Coal Combustion Waste Impoundment

Round 7 - Dam Assessment Report

Walter Scott Junior Energy Center

MidAmerican Energy
Council Bluffs, Iowa

BLACK & VEATCH
CONSULTING ENGINEERS
PROJECT 6247

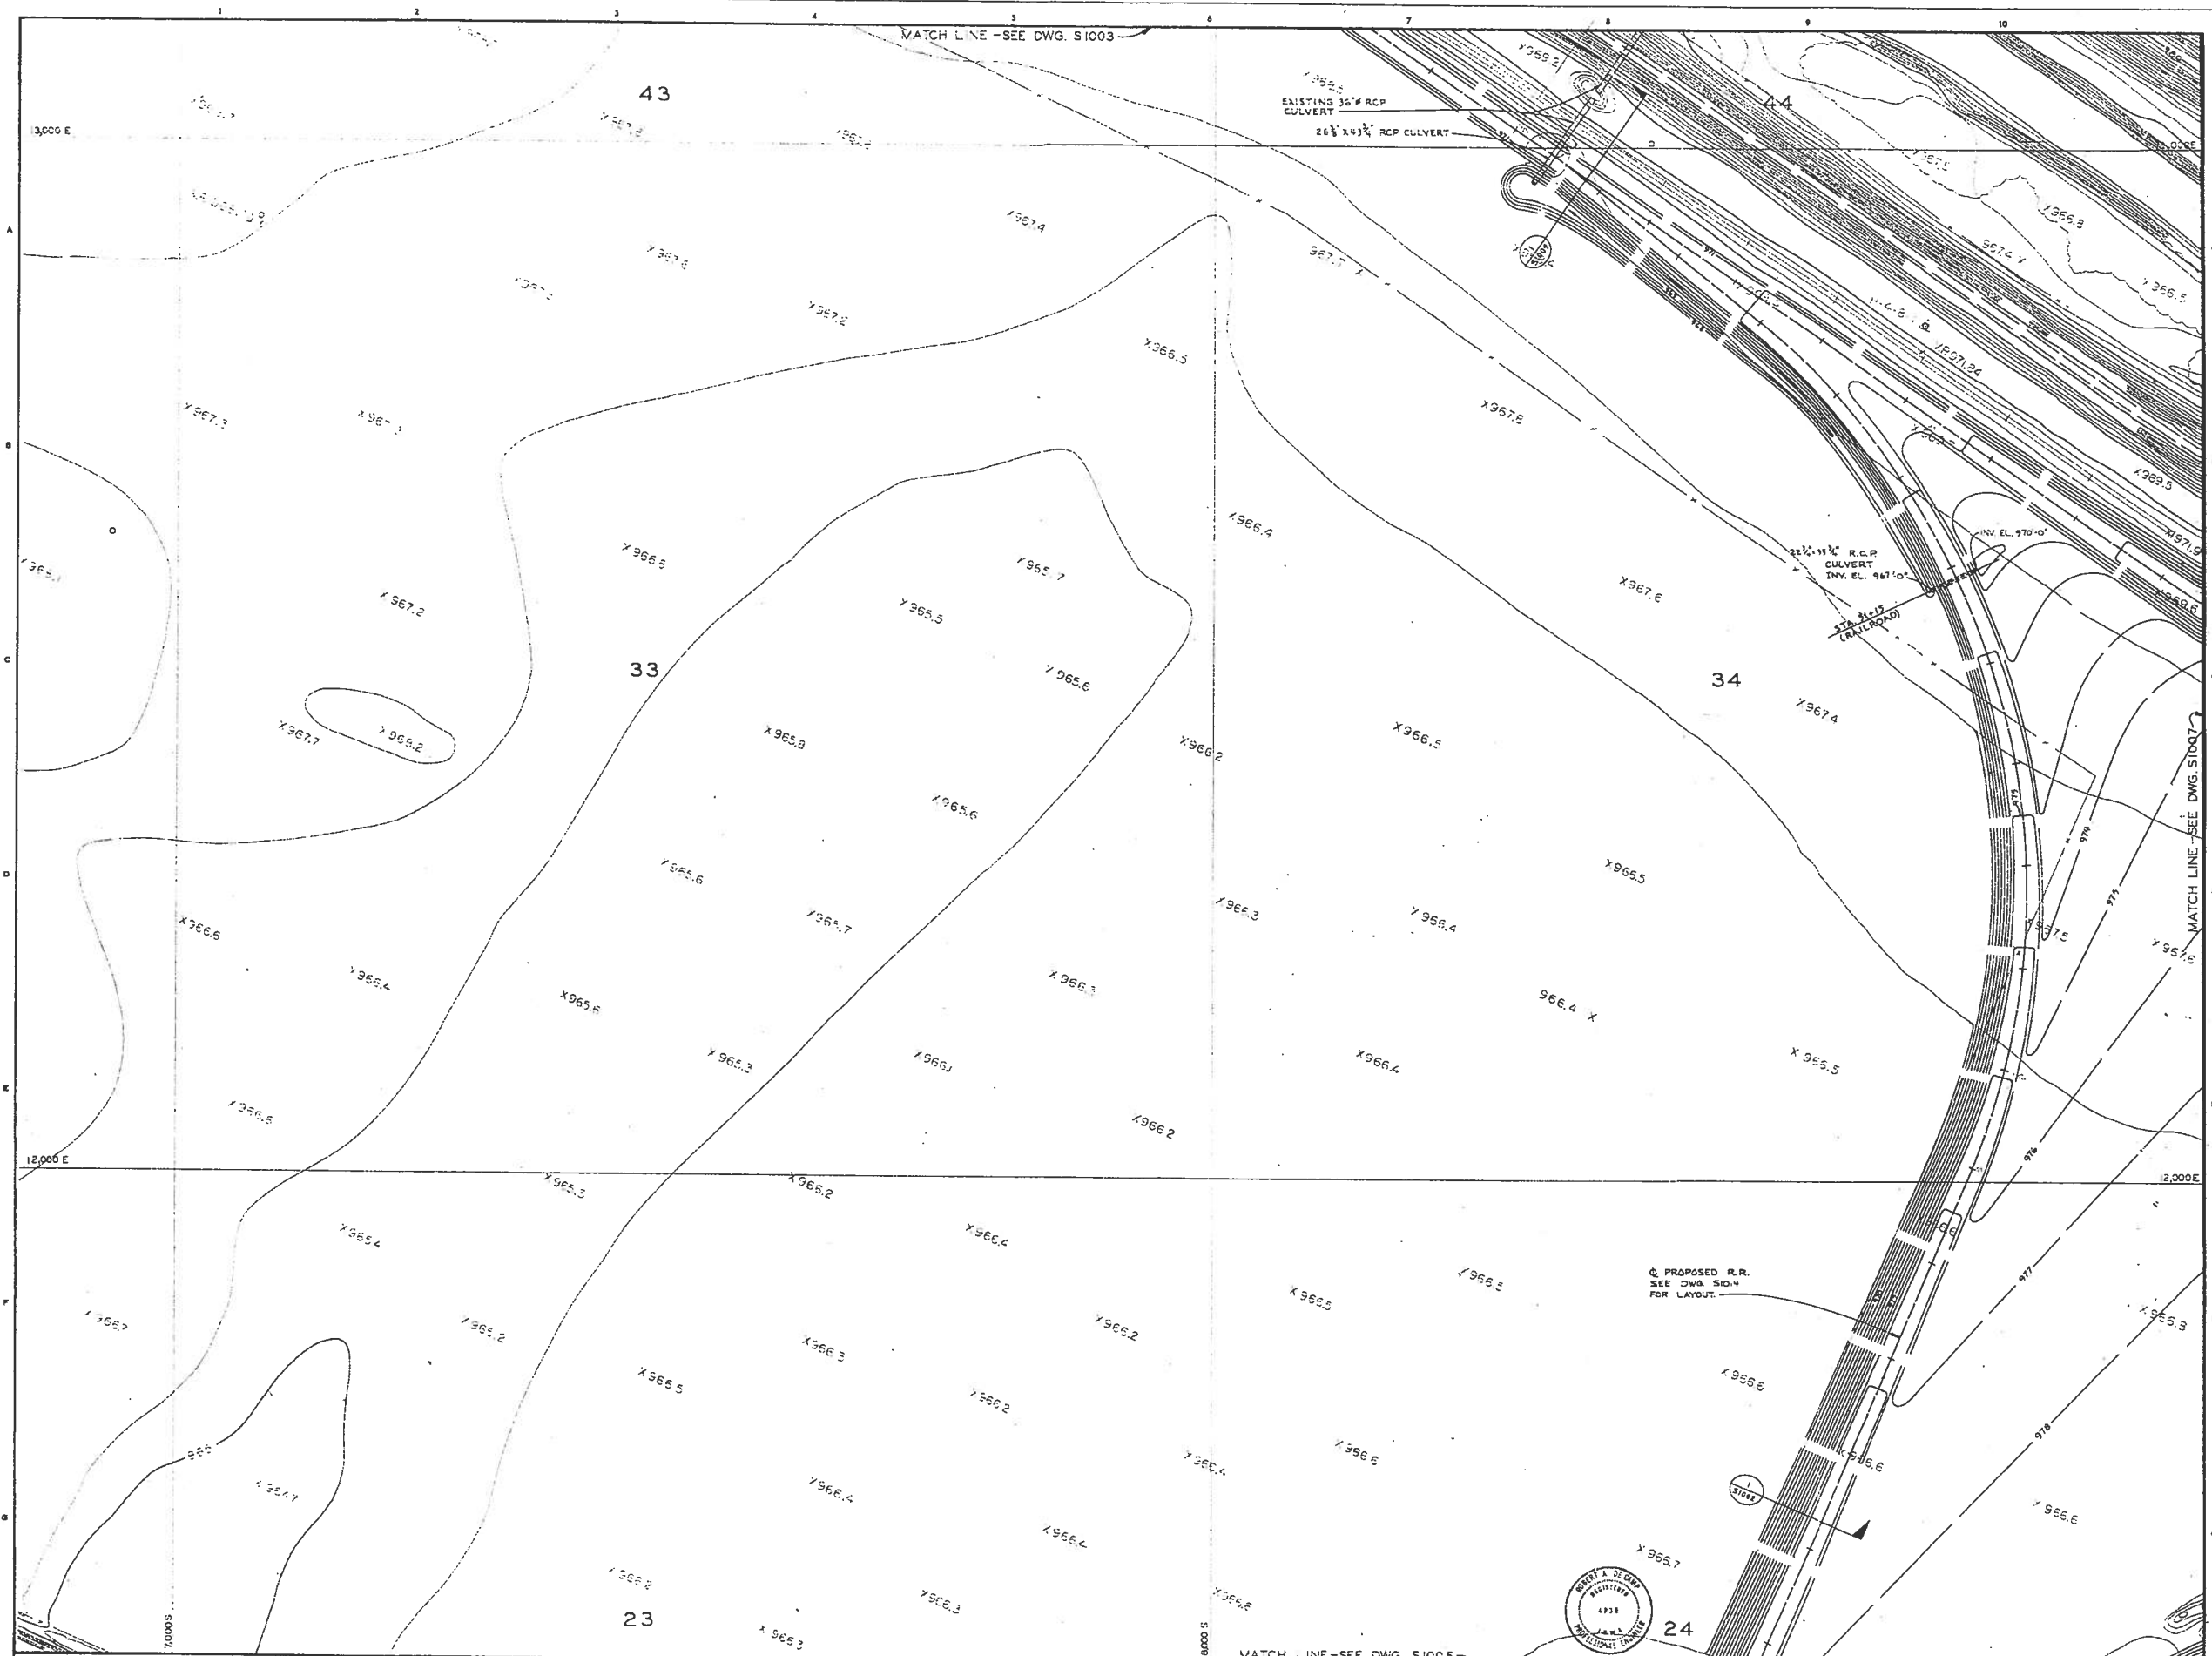
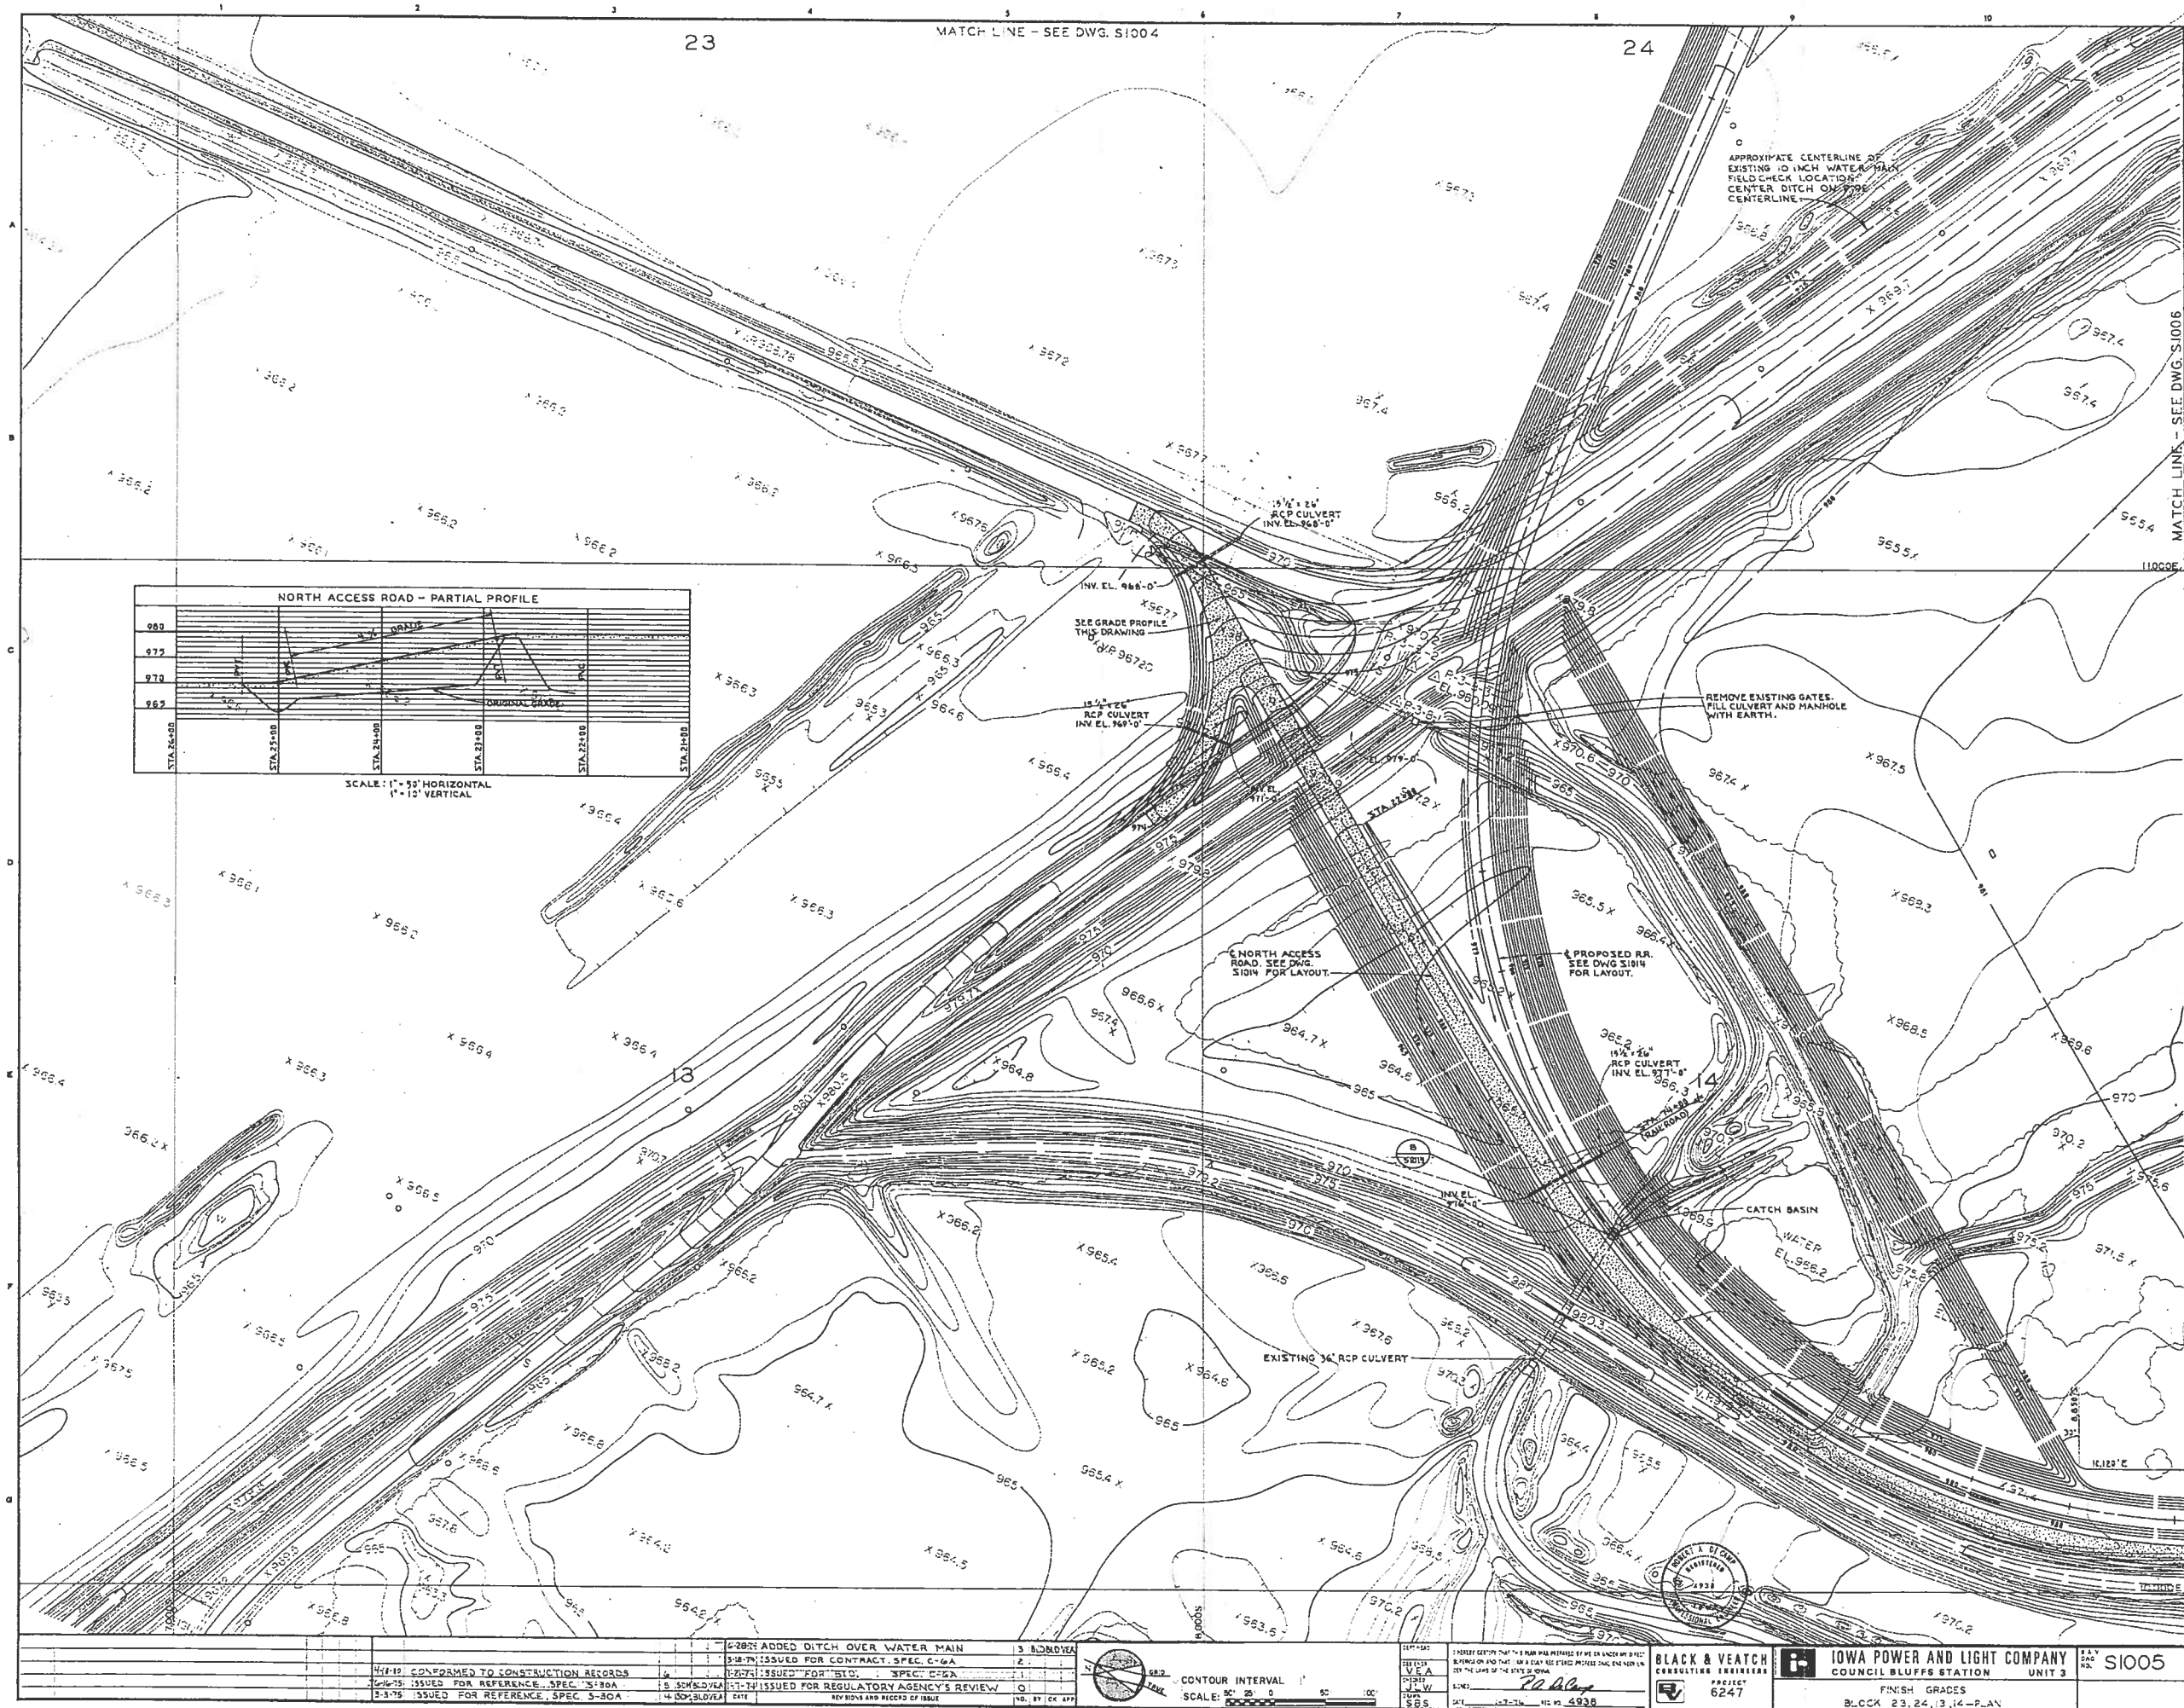
Supporting technical documents are generally adequate for the purposes of this review and assessment, although furnished drawings show original design features and do not reflect as-built features or all modifications that have been made since original construction (e.g., the SIRE railroad embankment built across the western part of the ash basins does not show on any of the furnished drawings).

Descriptions provided are generally sufficient. As noted above, furnished drawings do not show or note as-built features or all modifications that have been made since original construction.

horizontal (H) to 1 vertical (V) side slopes. The final design grades of the levees and dikes of the North Ash Pond are shown on the Finish Grades plans in Appendix C - Doc 1.3. However, the crest of the south side levee is actually about 3 feet higher than shown on the Finish Grade plans. MidAmerican indicated that the USACE raised the Mosquito Creek and Pony Creek levees in the early 1980s, and the change in height resulted in a slope of the crest from elevation 982 feet to 983 feet. However, a recent survey of crest elevations around the perimeter of the pond suggests that the Mosquito Creek levee was not raised (see Appendix D - Item 2).

Update project documents to include or note current features of the ash basins and modify or supplement the documents as needed when changes are made in the future. For example, the recently completed crest elevation profiles around both ash ponds surveyed by HGM Associates, Inc. (Appendix D - Item 2) serves to provide documentation of current crest elevations, which should be referenced on official project plans.
